New Jersey Offshore Wind Solicitation #2

RESPONSES OF OCEAN WIND II, LLC TO CLARIFYING QUESTIONS SET 1

(February 1, 2021)

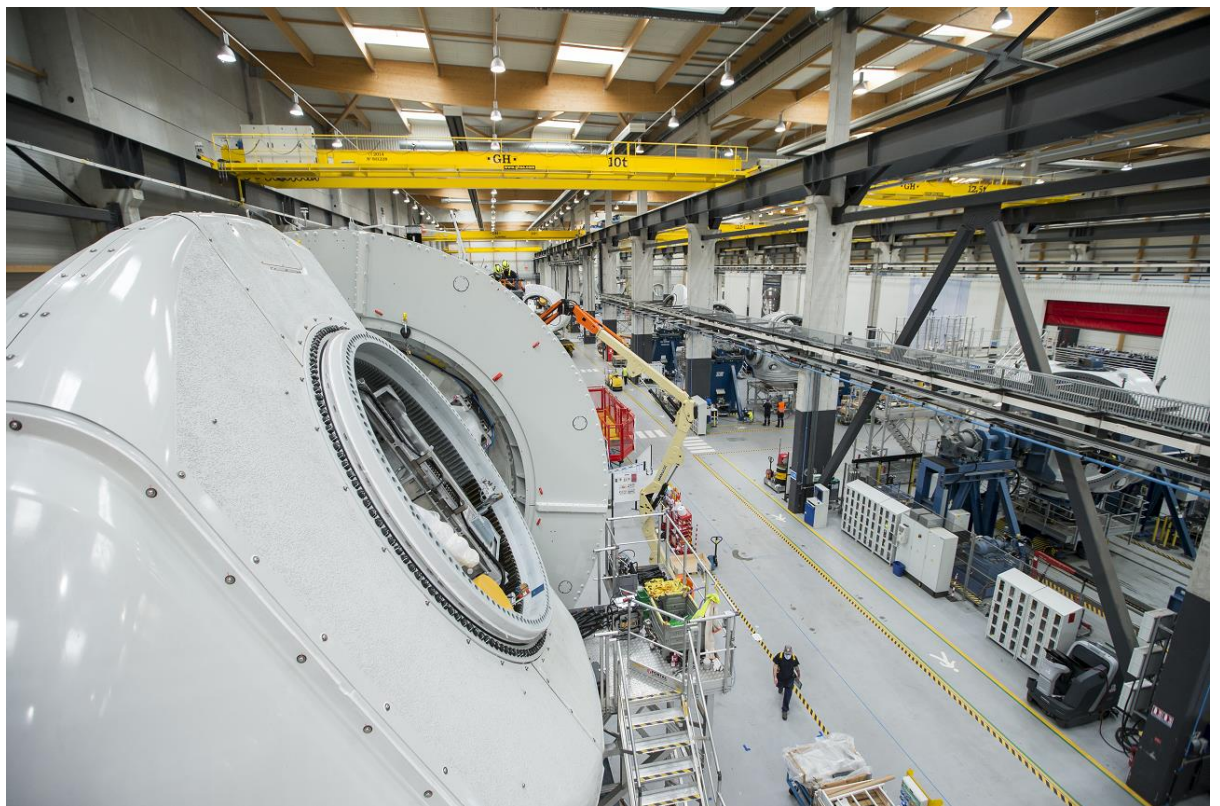
29. Section 8.2.2: Please explain why the GE nacelle facility at the NJWP would be a “unique opportunity for New Jersey” (Application, p. 8-9), given that other OSW developers can also partner with GE or other suppliers of WTGs.

Ocean Wind II, LLC Response – The localization of the supply chain, and specifically the construction of new manufacturing facilities, comes with an additional capital cost that, in the context of a low volume industry such as offshore wind, typically far exceeds any cost benefit associated to localization. Manufacturers cannot absorb these additional costs, so they are transferred to developers who must incorporate these cost adders into their bids.

Furthermore, prior industry experience from the onshore wind industry shows that the establishment a nacelle assembly facility will immediately encourage the development of facilities for the production of other supply chain parts in close proximity to the nacelle facility...so called manufacturing clustering effect. Such development of facilities for internal nacelle components (electrical components, controllers, molded parts, structural parts, hydraulic systems, etc.) is expected as many of the required components are significant in size, and geographic proximity facilitates logistics. Of the three main turbine component manufacturing opportunities...nacelles, blades, and towers...nacelles has the most inherent ability to lure other manufacturers to the area because of the nature of "assembly" which entails literally putting together hundreds or thousands of parts and/or subsystems into a nacelle. GE has confirmed its intention to encourage its suppliers to regionalize around the location of its nacelle assembly location. In fact, Ørsted North America's CEO, David Hardy, during his time at Danish wind turbine manufacturer Vestas, witnessed the establishment of an onshore nacelle assembly factory in Brighton, Colorado in 2010 and the associated influx of component suppliers to the area. Vestas is a global leader in onshore wind, however, remains unproven offshore. The nacelle facility in Brighton and other initiatives were part of making Colorado a clean energy hub. See e.g. this New York Times piece for reference

The Applicant therefore believes this is a unique and amazing opportunity for New Jersey to not only bring a beacon of American industry, GE, to the State with a state-of-the art facility, but also to attract the associated anticipated supply chain developments that will likely follow. As one of the two only legitimate offshore wind turbine OEMs (Siemens Gamesa being the other one) and as the only American OEM in the space, Ørsted believes establishing supply chain components with GE is a tremendous opportunity for NJ. Not all OEM components are created equal and will have long-lasting global demand.

Please see below some images of GE's nacelle assembly plant in Saint Nazaire, France in supplement to the one supplied in the Application. These pictures are for illustrative purposes only, as the NJ plant might differ in its final configuration.
